BULLETIN #2

DATE June 21, 2018

PROJECT NAME Saint Kenneth Catholic Church
Worship Space Addition & Renovation

PROJECT NUMBER 2014166

Scale: 1-1/2" = 1'-0"
Sheet
A522

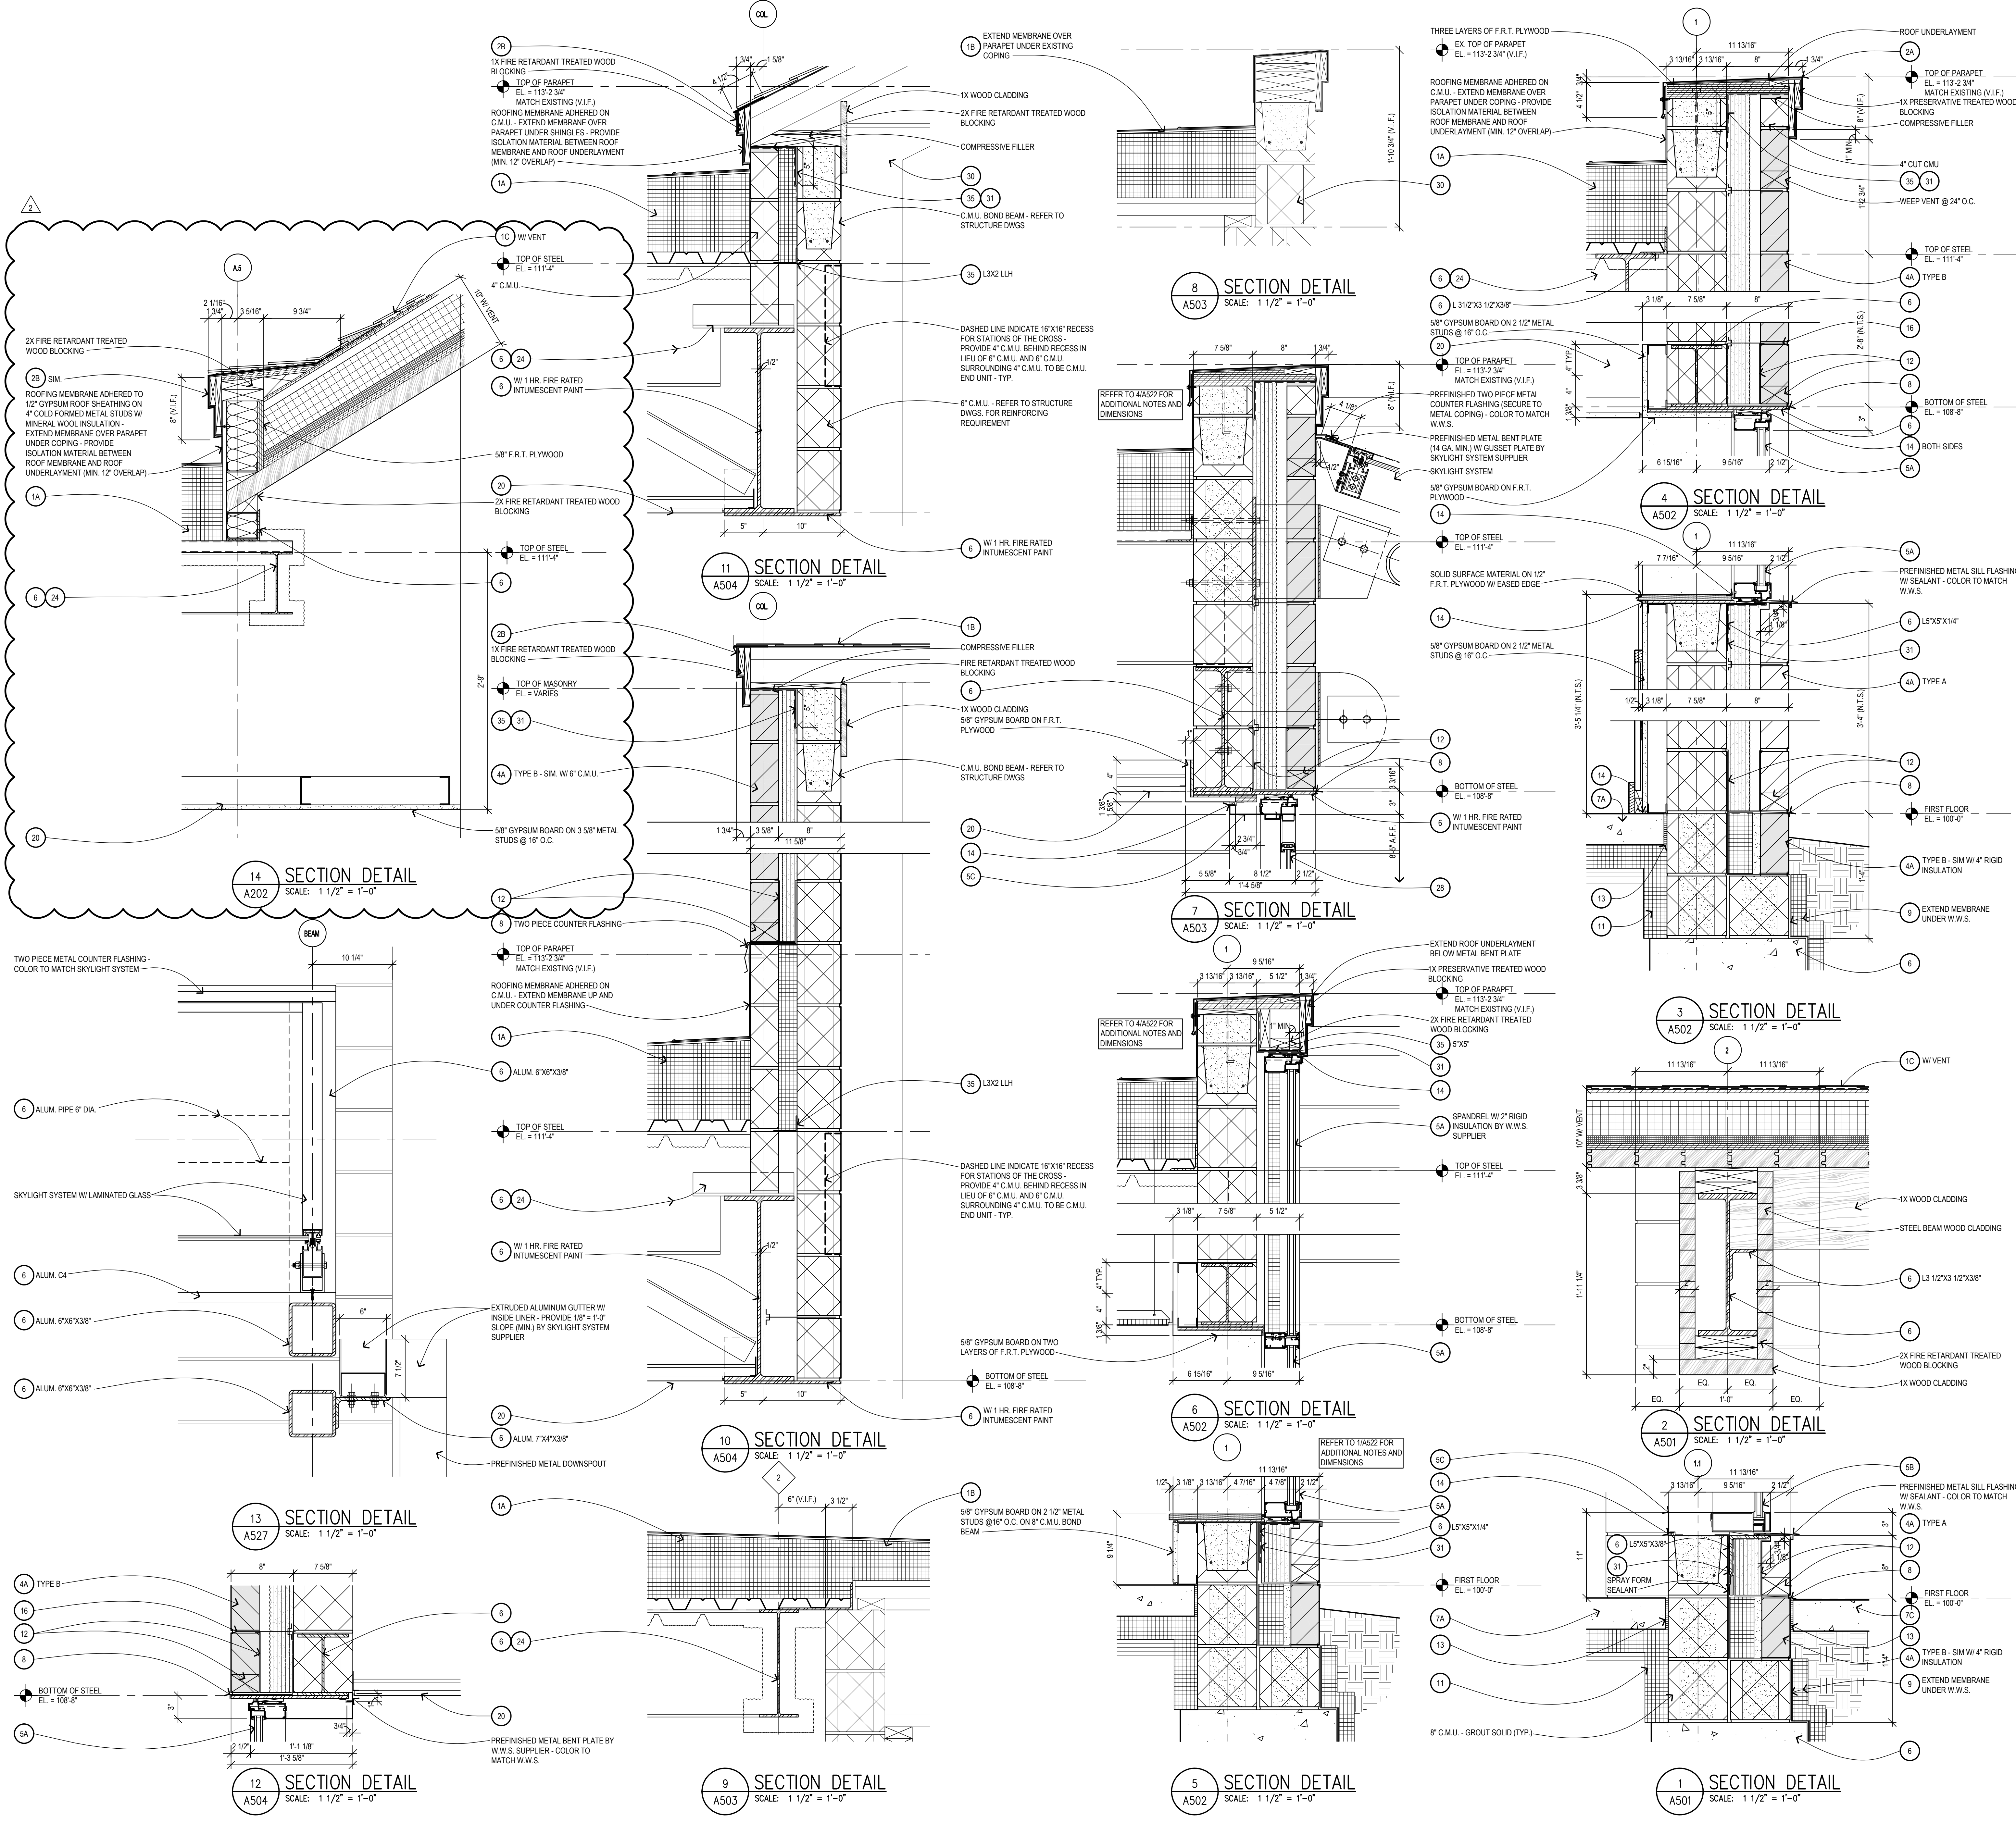
- A. Added wood decking detail, 14/A522, above soffit below column line A.5. for clarification.
- B. See Structural for added steel beam support.

Scale: VARIES
Sheet
A571

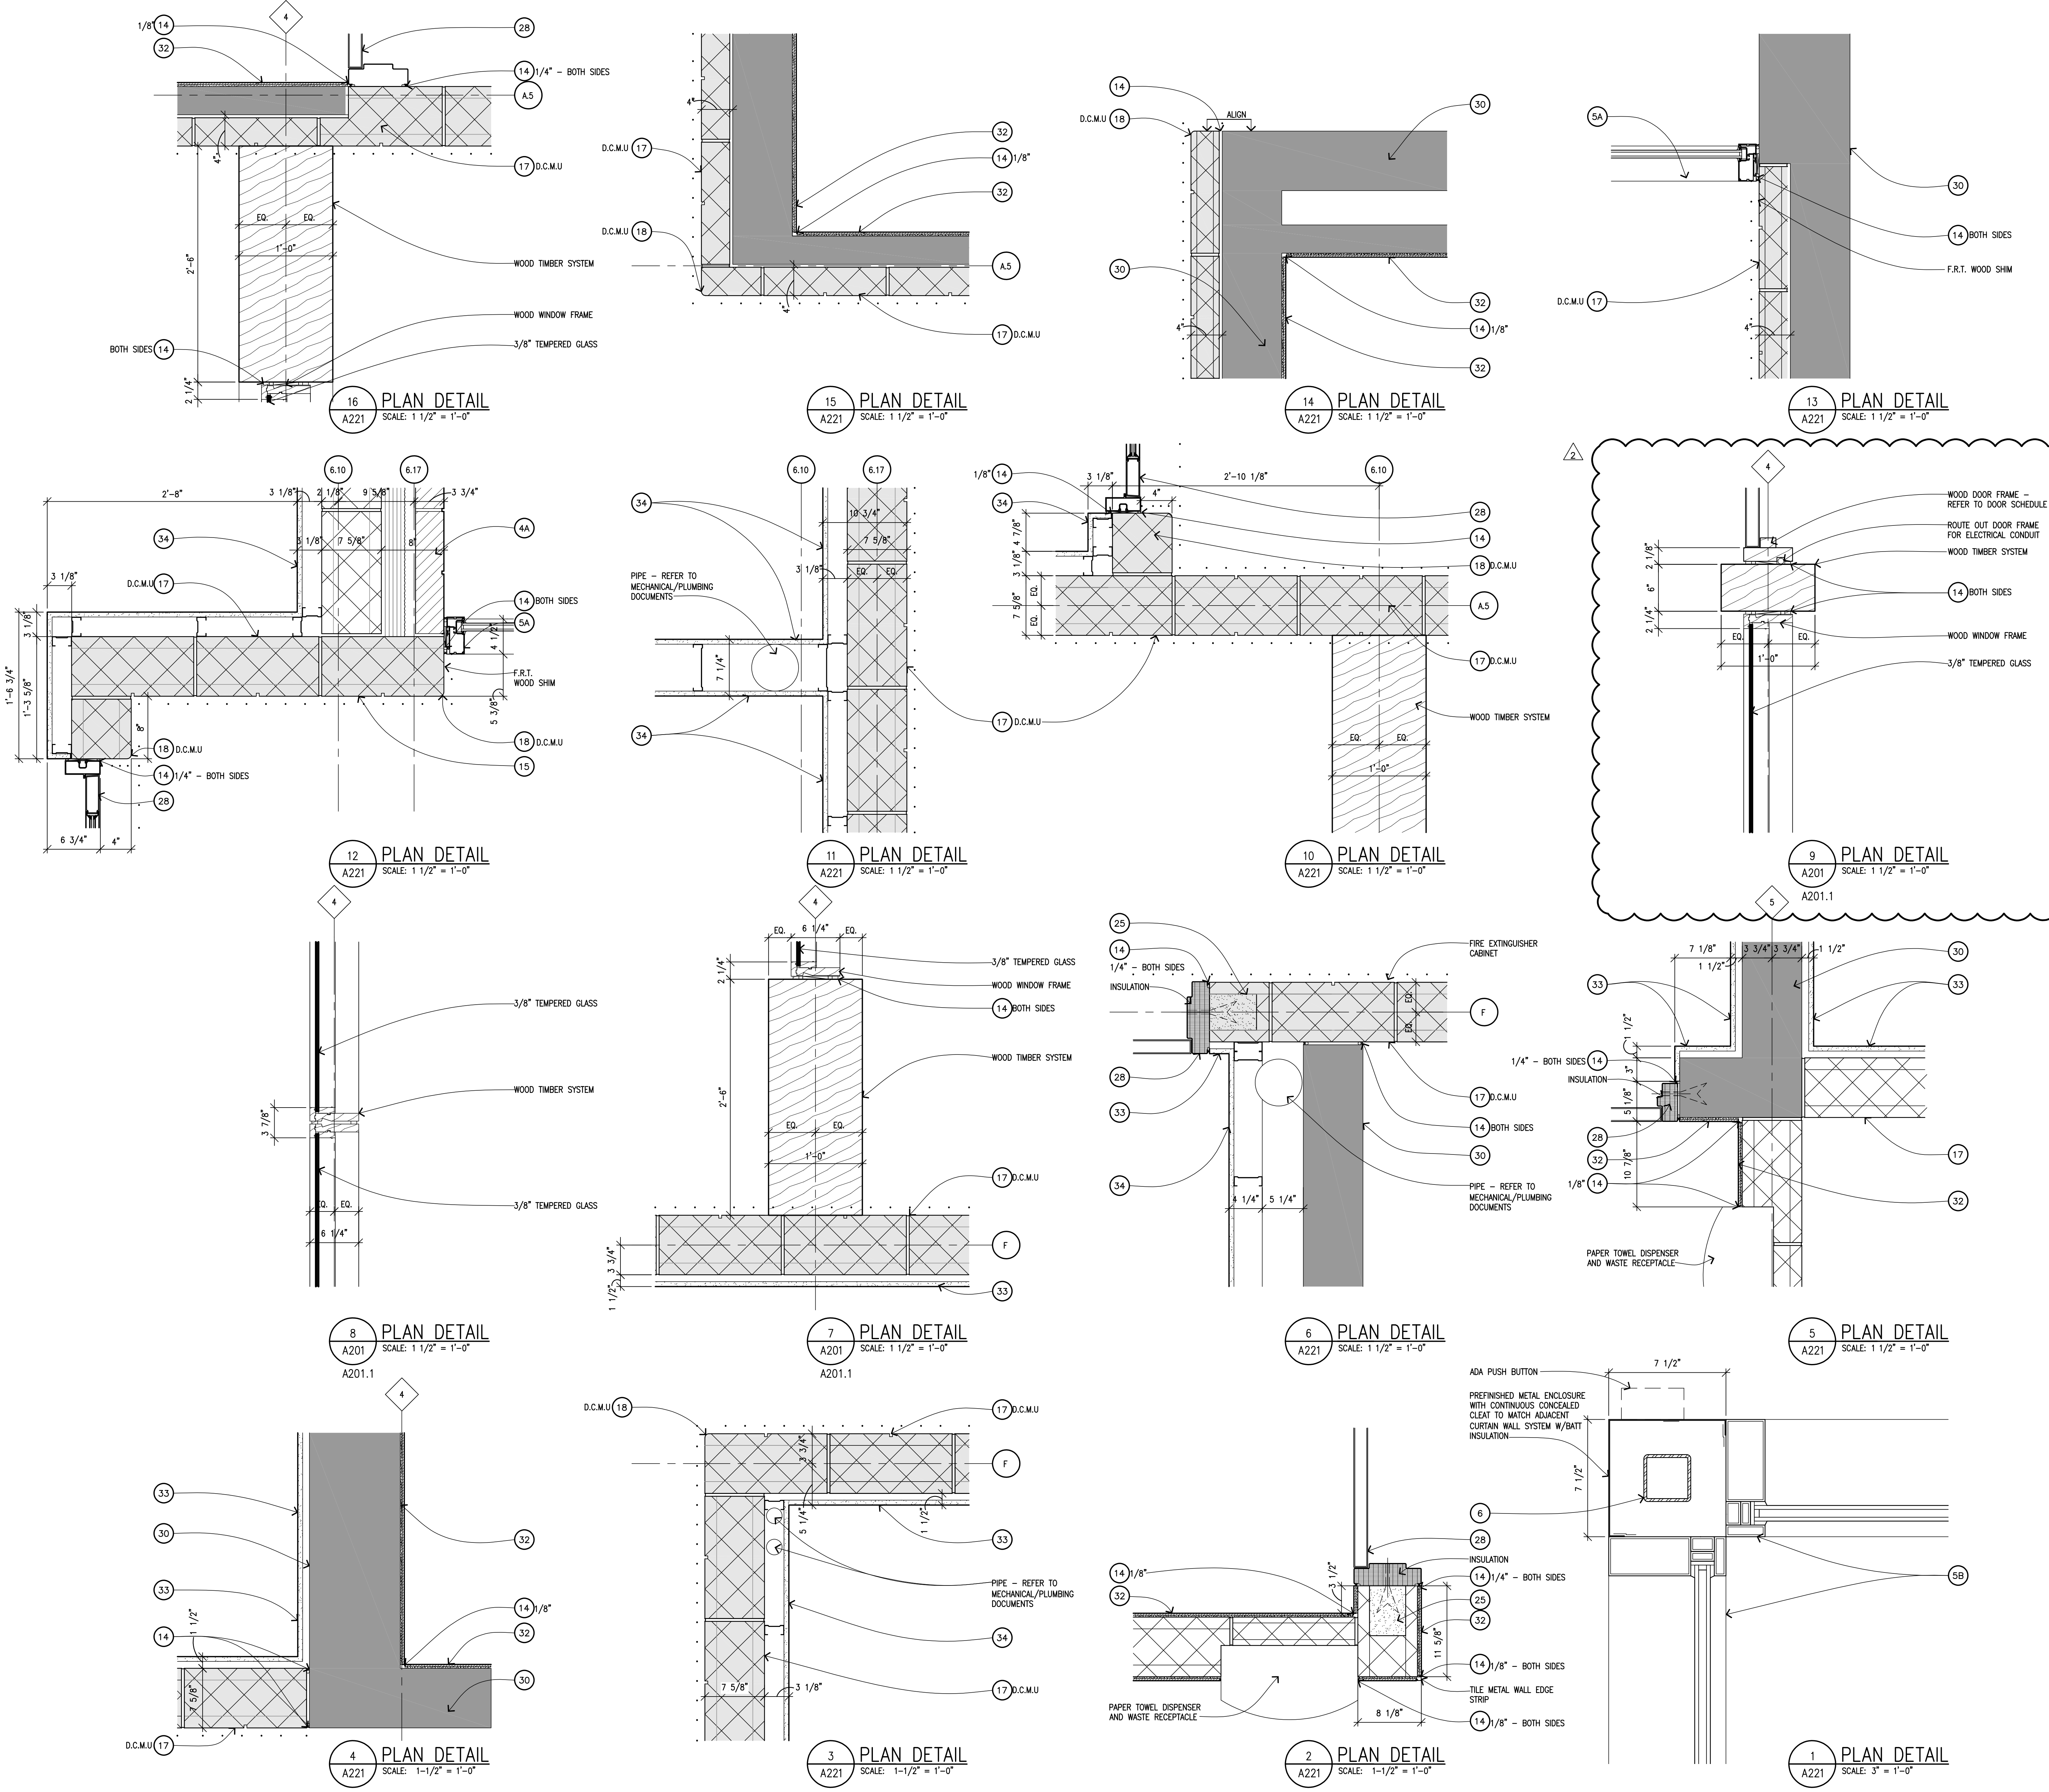
Item No. 1 – Wood Window System Exit Sign Details **Refer to Drawings A411, A571, A601, A901**

- A. Detail clarification showing conduit routing and installation of exit signs at doors 110A and 110B
